ARCHITECT'S SUPPLEMENTAL INSTRUCTIONS

PROJECT:	Roosevelt Lofts Historic Rehabilitation San Angelo, TX	Report No.	Five (5)
OWNER:	Overland Property Group 234 N. Santa Fe Ave, Suite A Salina, KS 67401	Date	June 5, 2024
CONTRACTOR:	MCP Group 3501 SW Fairlawn Rd. Topeka, KS 66614	Architect's Proj No.	22-3281
		Contract For:	General Construction Mechanical, Electrical

DESCRIPTION:

A2.6

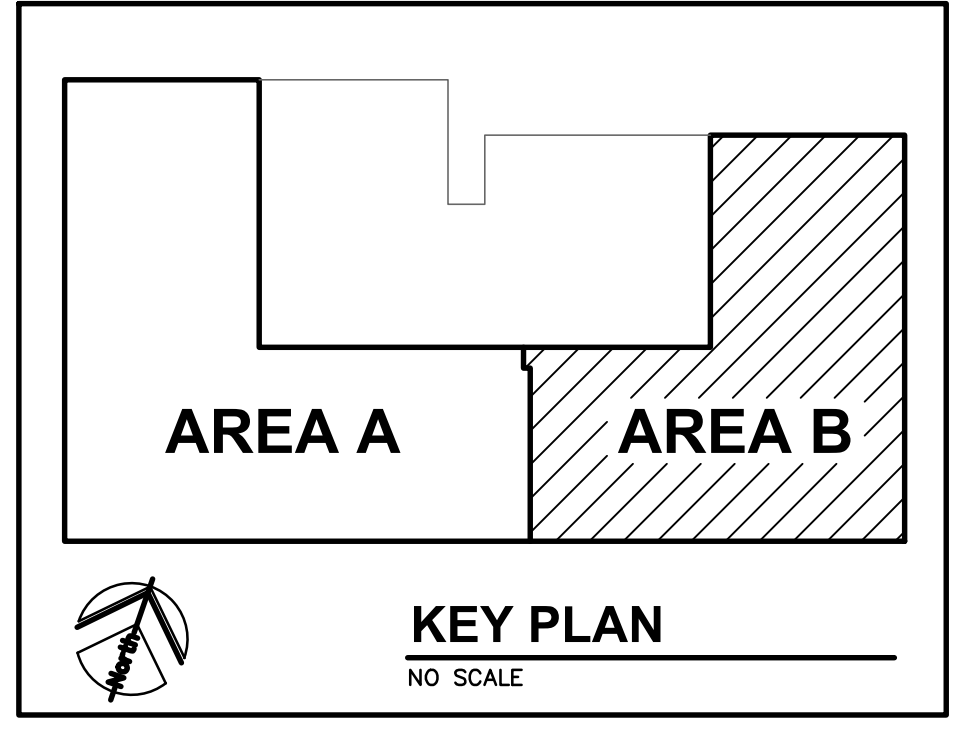
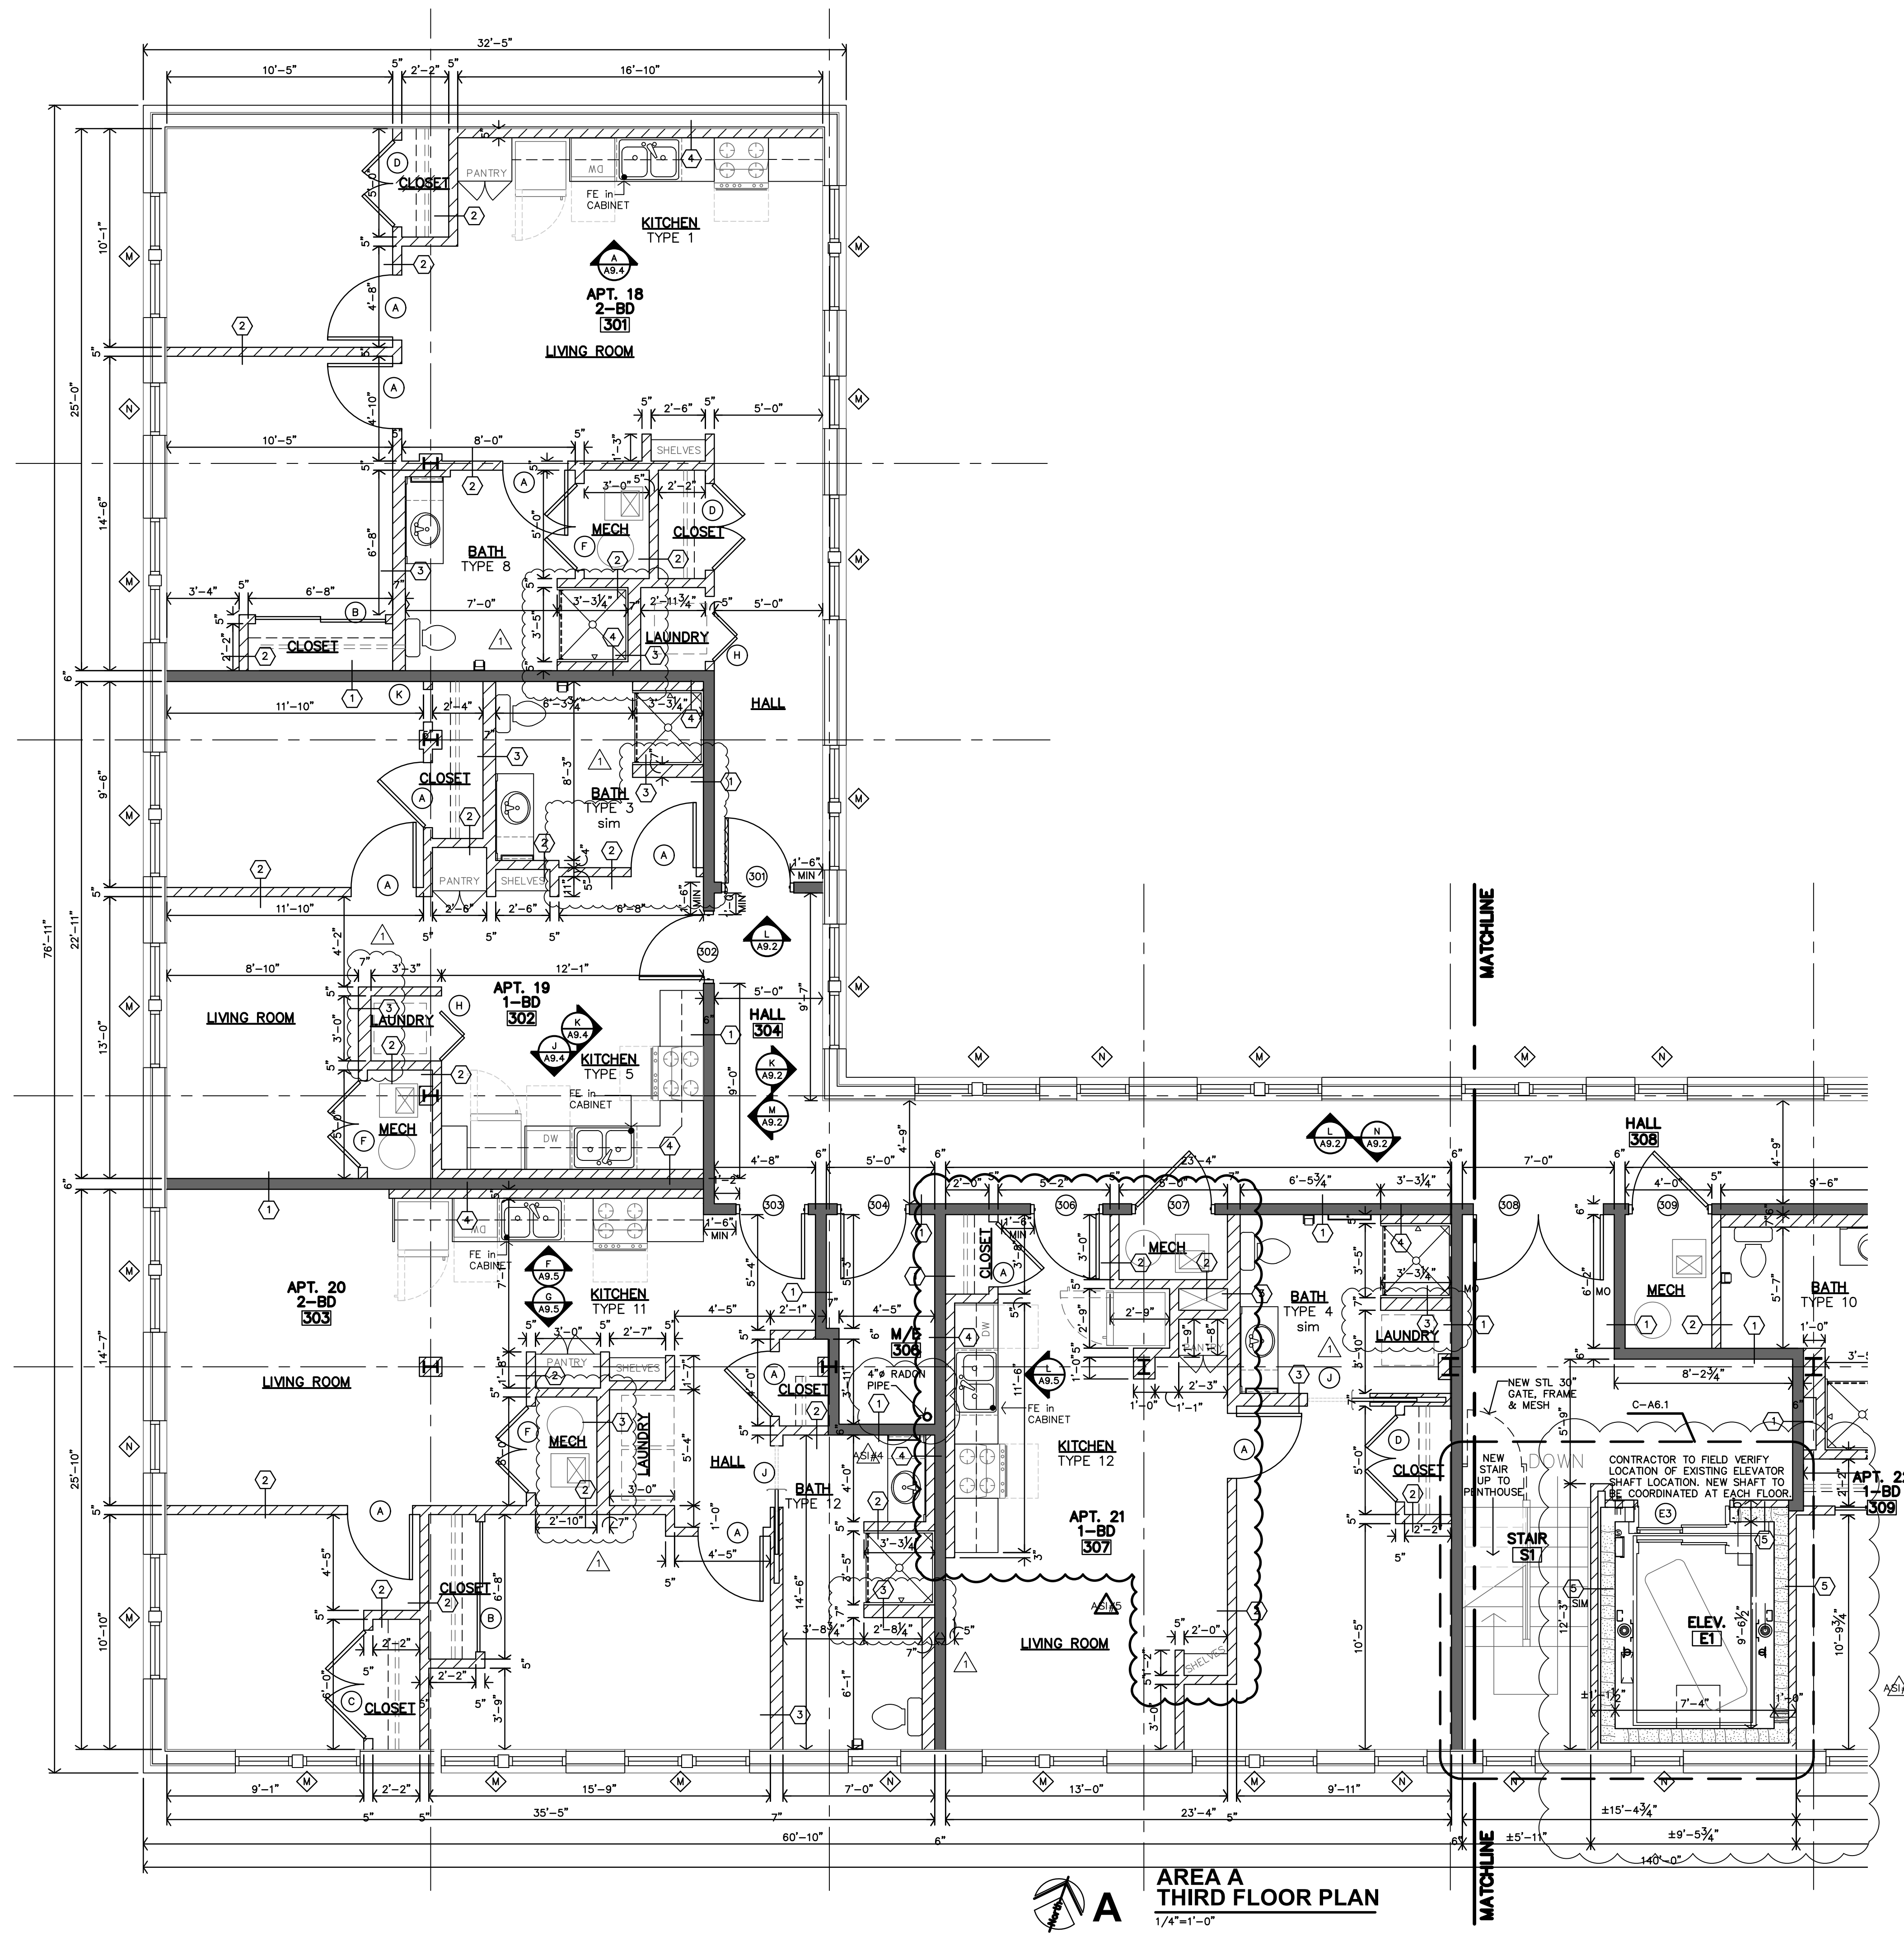
4. Door 121 (into Apt. 5, Rm #118) – shift door & frame 24" to the east, and swing changes to Right-Hand. Revised plan on Sheet A2.3
5. Kitchen Party Wall between Apt. 14 (Rm #209) & Apt. 15 (Rm #211) – shift 6" to the east. Revised plan on Sheet A2.6

A2.7

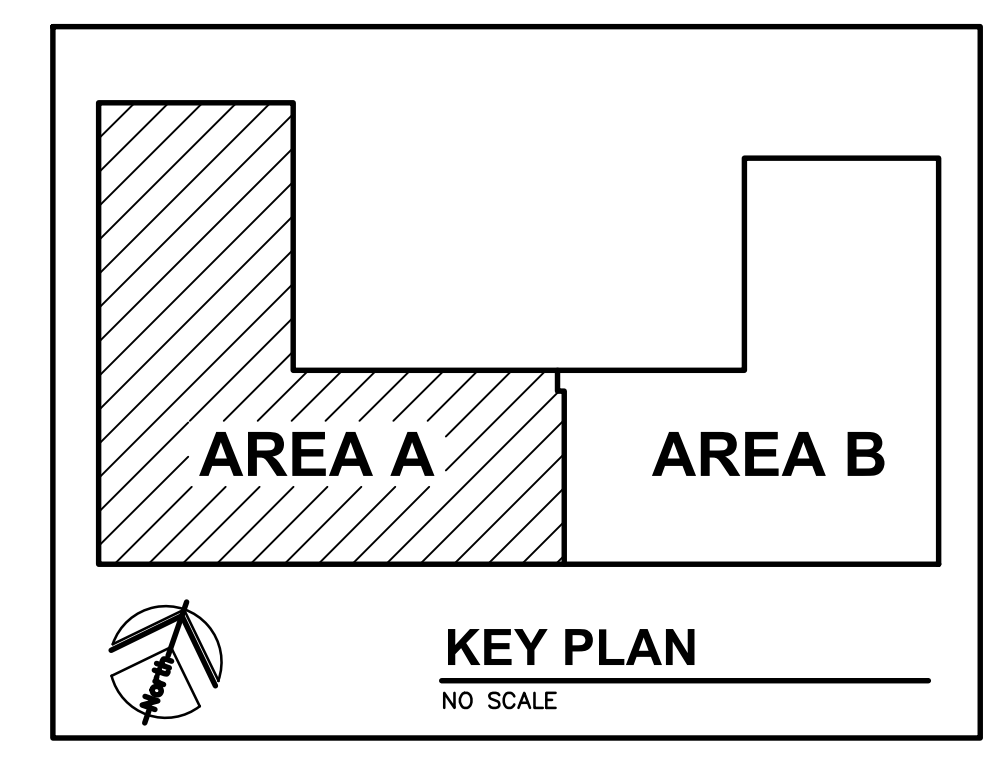
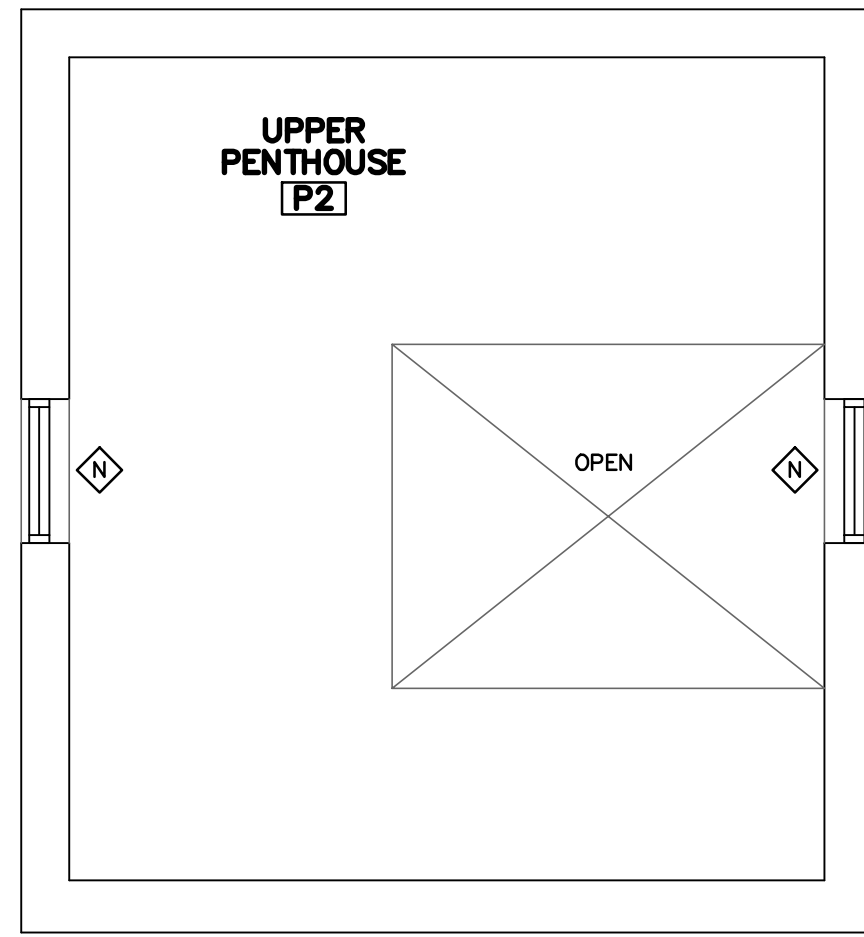
3. Apartment 21 (Rm #307) - Kitchen casework, fixtures, appliances, closet & shelves have been arranged to avoid a conflict between the entry door clearances and the refrigerator. Reference revised sheets A2.7, A9.5, A7.2, M1.9, E1.3, E1.12

A AREA B THIRD FLOOR PLAN
1/4"=1'-0"

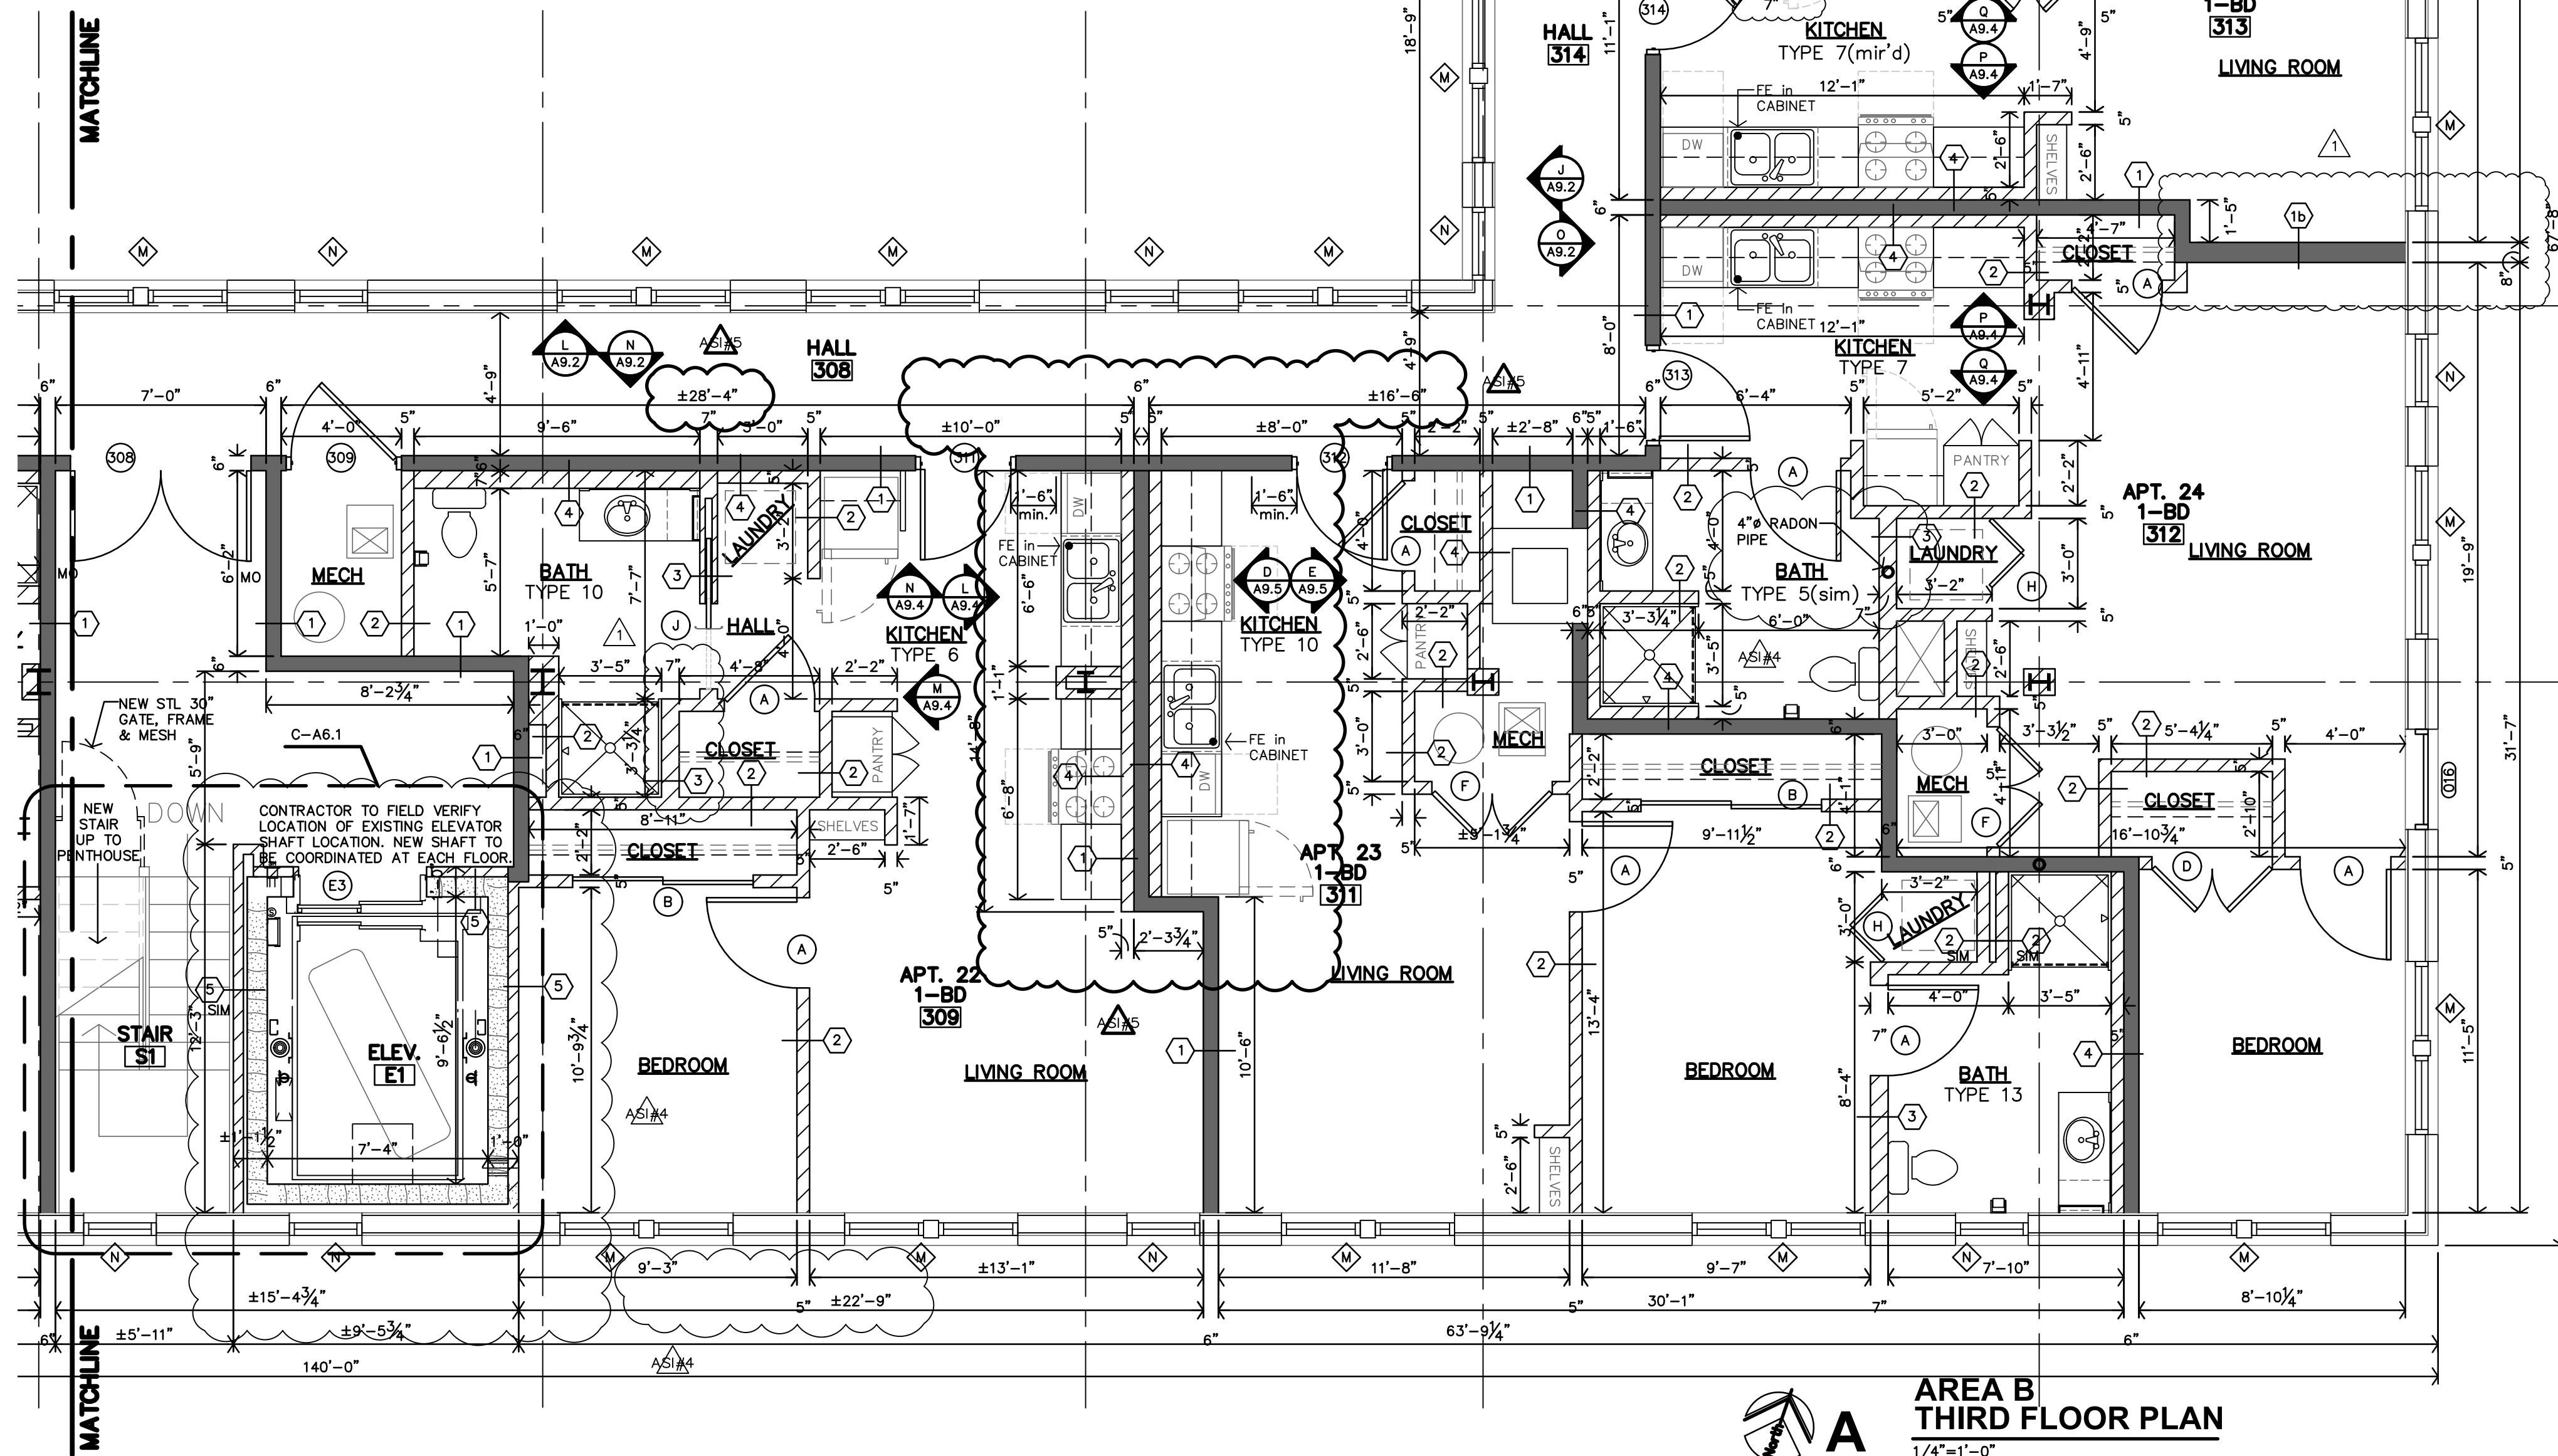
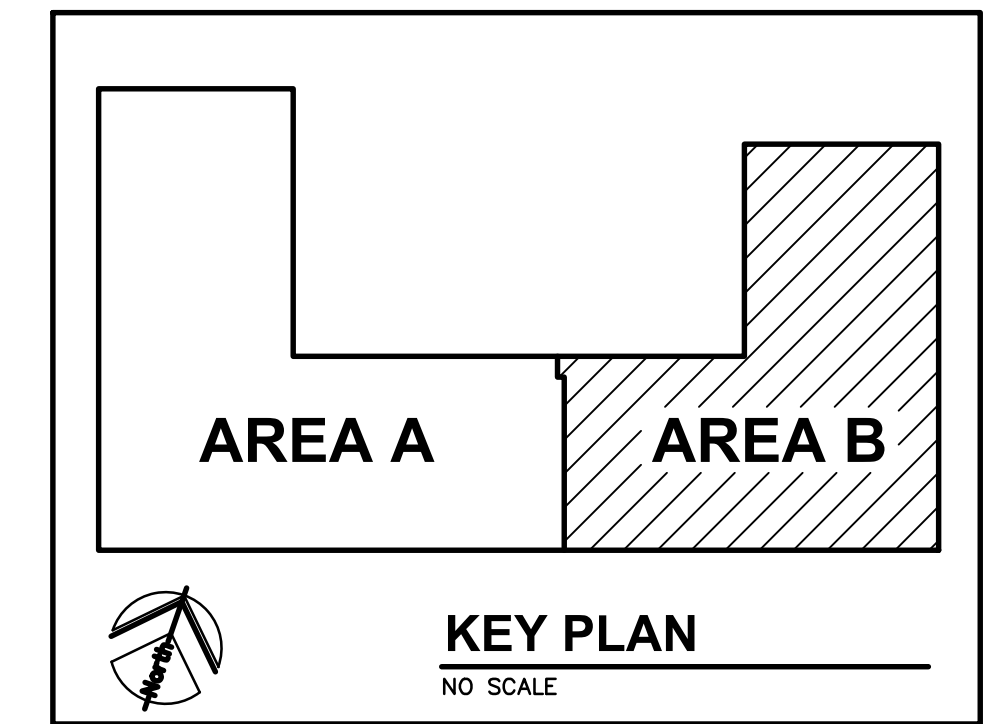
6. Kitchen Party Wall between Apt. 22 (Rm #309) & Apt. 23 (Rm #311) – shift 6" to the east. Revised plan on Sheet A2.8
